# HOTSTART®

## PRODUCT IMPROVEMENT NEWS

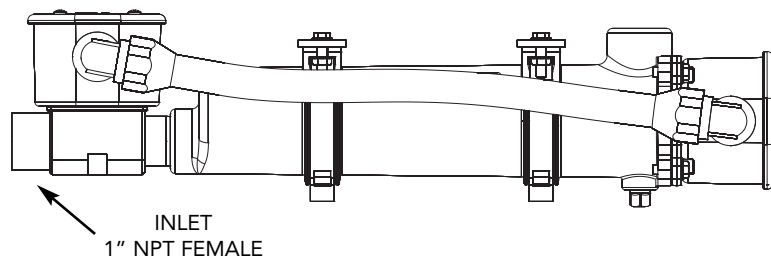
HOTSTART is introducing a new improvement for its line of tank style coolant heaters. The thermostat housing assembly will change from plastic to aluminum on all CB/CL, SB/SL and WL series engine heaters. This will improve durability, performance and installation flexibility. The new thermostat design will be available January 1, 2010.

The updated housing features a 1" female NPT threaded port for easy connections with male NPT threaded adapters. This will simplify hose connections and eliminate excess hose couplers. The new assembly also features easy access to the interchangeable fixed or adjustable sensing unit.

The new thermostat design will be available as a component on thermostatically controlled tank style coolant heaters or as a replacement unit for existing and future HOTSTART heaters. Customers will notice a slight difference in part numbers for heaters that include a thermostat assembly. The three-digit suffixes on existing part numbers will change to -200.

Example of current part number: CB125210—000

Change to: CB125210—200
